UNITED STATES PATENT AND TRADEMARK OFFICE

APPLICATION NO.	FILING DATE	FIRST NAMED INVENTOR	ATTORNEY DOCKET NO.	CONFIRMATION NO.
10/822,007	04/12/2004	Hideaki Shimoda	251774US2	1570
22850	7590	08/08/2005	EXAMINER	
OBLON, SPIVAK, MCCLELLAND, MAIER & NEUSTADT, P.C. 1940 DUKE STREET ALEXANDRIA, VA 22314			GLENN, KIMBERLY E	
			ART UNIT	PAPER NUMBER
			2817

Office Action Summary

DETAILED ACTION

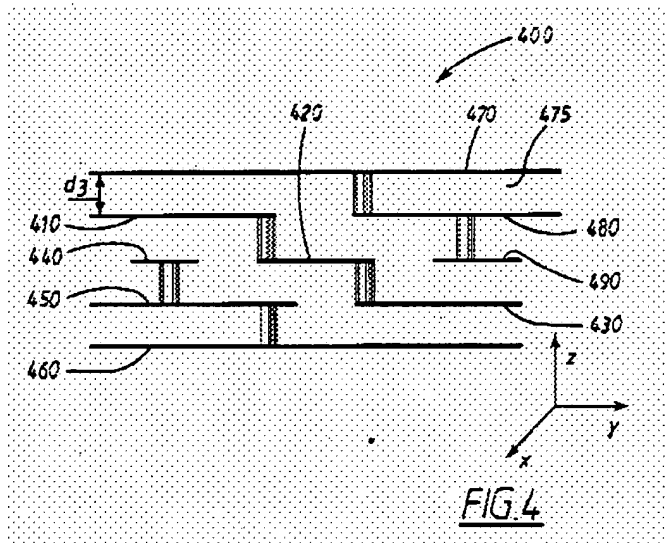
Harju et al disclose in figure 4, a transmission line arrangement comprising a first conductor section 410 in a layer of a dielectric substrate 475; a second conductor section 430 in a different layer of a dielectric substrate; a third conductor section 420 provided in a layer between said first conductor section and said second conductor section wherein one edge of said third conductor section 420 is overlapped with said first conductor section 410 and another edge thereof is overlapped with the second conductor section 430, a first connection conductor for connecting said first conductor

section 410 to the one edge of said third conductor section 420 and a second connection conductor for connecting said second conductor section 430 to the another edge of said third conductor section 420. Harju et al further disclose a conductor 450 for shortening a distance between said first conductor section and a ground conductor 460. (Column 7; line 8 through column 9; line 3)

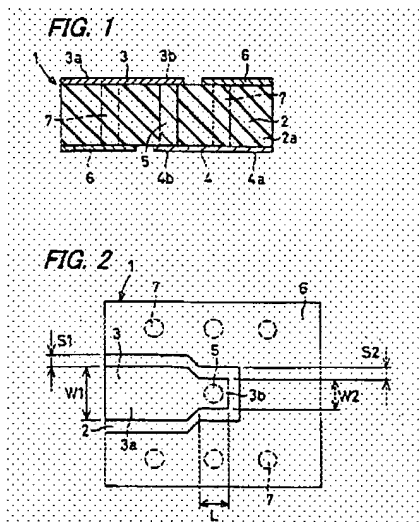
Shirasaki disclose in figure 1 and 2, a high frequency wiring board comprising of a first line conductor 3 having a width of an edge portion 3b thereof being different from a width of another portion thereof; and a second line conductor 4 different from the first line conductor 3, which is connected to the edge portion of the first line conductor. The first and second line conductor disposed in different layers of a dielectric substrate 2 respectively. The edge portion 3b the first line conductor is arranged to overlap with the second line conductor; and a through conductor 5 is provided to connect said edge portion of said first line conductor to said edge portion of said second line conductor. (Column 5; line 7 through column 6; line 56)
